ATTACHMENT 2
INTERNAL COUNCIL REFERRAL COMMENTS

NATURAL AREAS ASSESSMENT

TRANSPORT ASSESSMENT

URBAN DESIGN ASSESSMENT

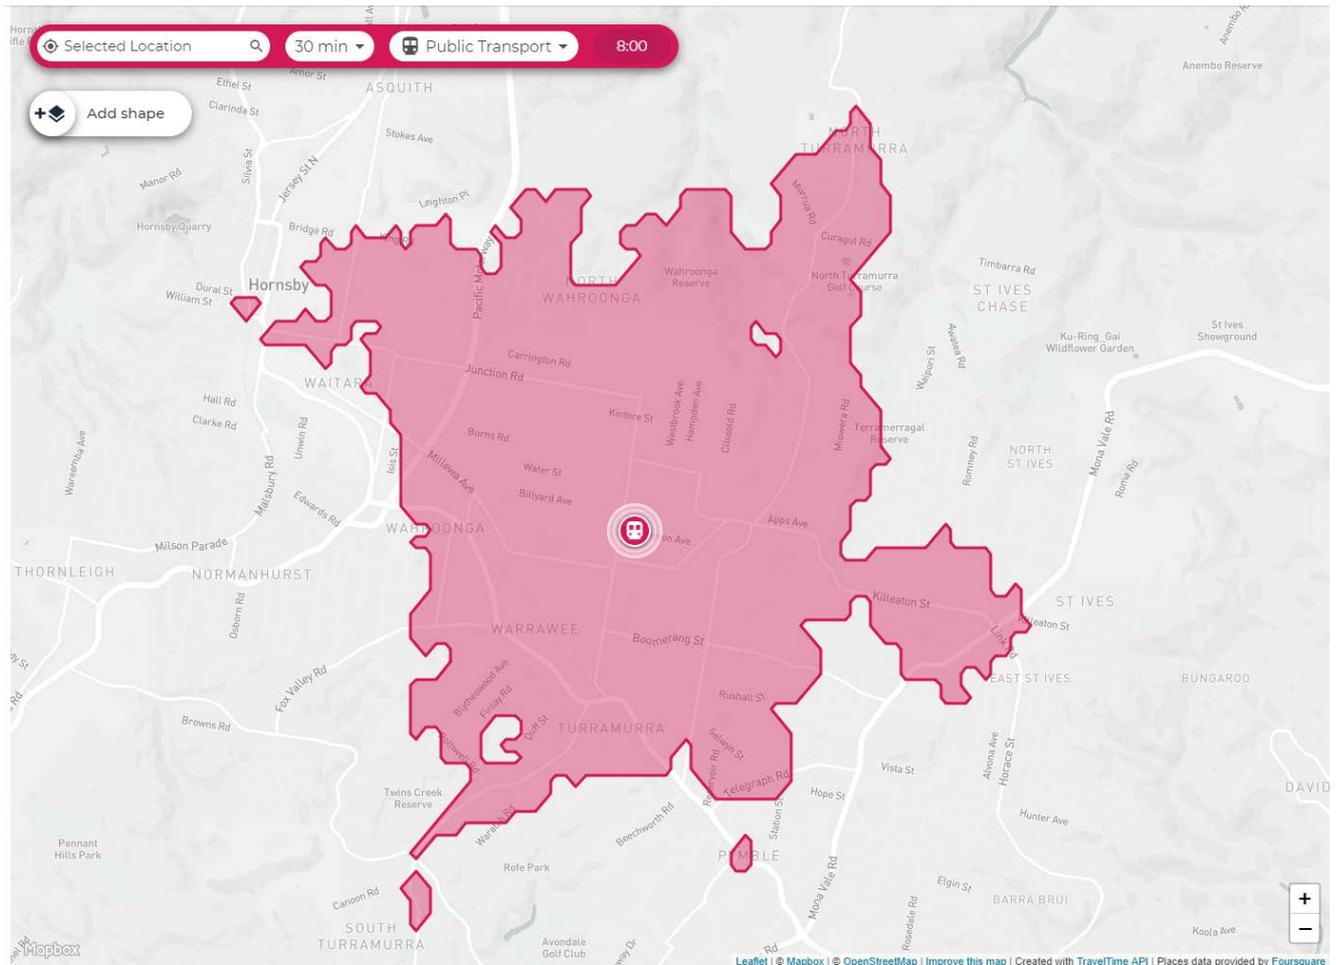
The diagram above (from <https://app.traveltimeplatform.com/>) indicates the extent of the 30 minute catchment by public transport around the site. As can be seen, the catchment draws in Turrumurra, Warrawee and Wahroonga (generally north of Pacific Highway), parts of St Ives and Pymble as well as the eastern edge of Waitara and Hornsby, but is relatively small and unlikely to provide access to a large workforce. Given the small public transport catchment and unrestricted nature of on-street parking in the vicinity of the site, it is likely to be highly car dependent for journeys to work.

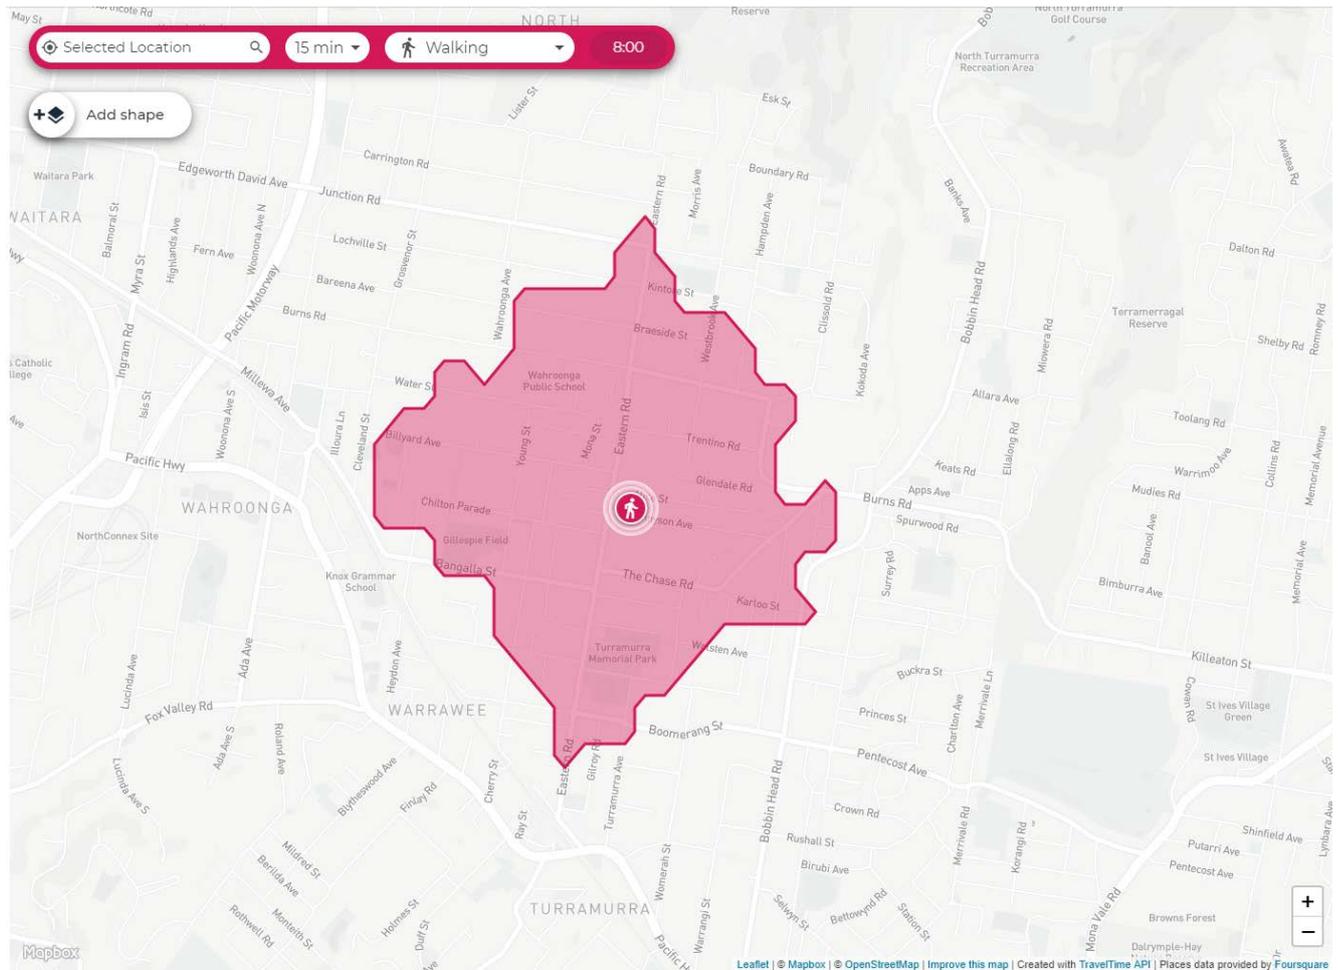
The diagram above (from <https://app.traveltimeplatform.com/>) indicates the extent of the 15 minute walking catchment around the site. The catchment is reasonably evenly distributed along the north-south and east-west axis (roughly being Eastern Road, and Chilton Parade/Tennyson Avenue respectively) and is characterised by approximately 950 low density dwellings, or a population of approximately 2,950. As the proposal to rezone the site would increase pedestrian demand across Eastern Road (to/from the western part of the walking catchment), consideration will need to be given (likely at DA stage) to improving crossing opportunities and additional pedestrian facilities on Eastern Road as well as across Tennyson Avenue and The Chase Road (where they meet Eastern Road), to facilitate and promote pedestrian access.

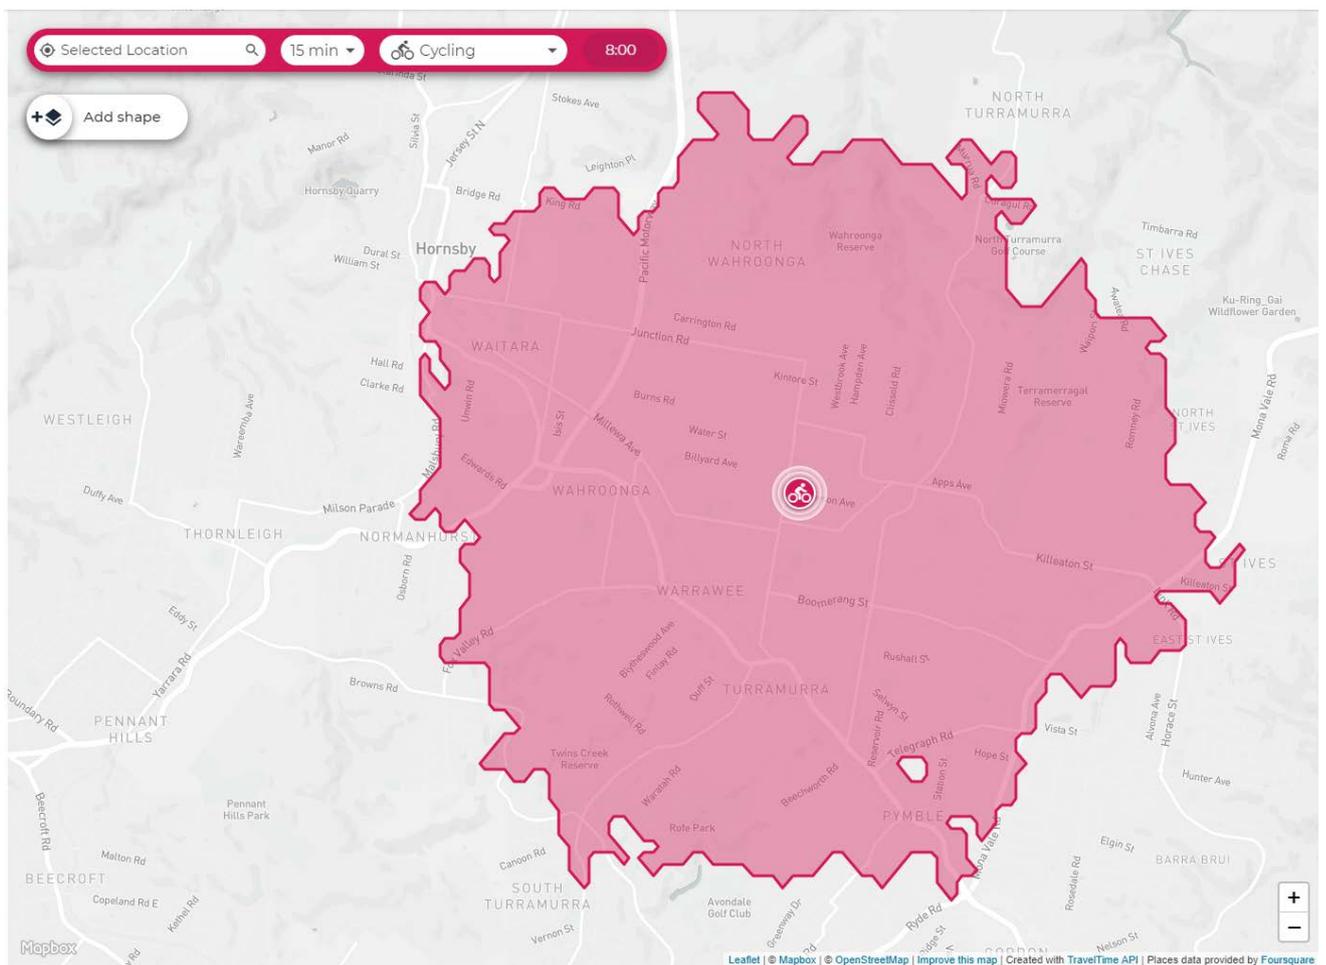
The diagram above (from <https://app.traveltimeplatform.com/>) indicates the extent of the 15 minute cycling catchment around the site. As expected, the 15 minute cycling catchment is larger than the 15 minute pedestrian catchment, and generally covers Turrumurra, Wahroonga, Warrawee, St Ives (east of Mona Vale Road), parts of Pymble, Waitara and eastern parts of Hornsby. However, the bicycle infrastructure in the catchment is largely undeveloped, with the only facilities of note being the shared user path along Link Road/Killeaton Street and Burns Road (providing connections to St Ives), and the on-road shoulders on Bobbin Head Road (providing connections to Turrumurra/North Turrumurra). Apart from these facilities, the majority of cycling is expected to be confined to either on-road/mixed use cycling or cycling on footpaths (where permissible).

While the absence of formalised cycling facilities anywhere near the site is unlikely to encourage cycling as an alternative means of transport in the short to medium term, this should not obviate the need to provide bicycle support facilities (bike racks, change rooms/lockers and showers) as part of any future development application.
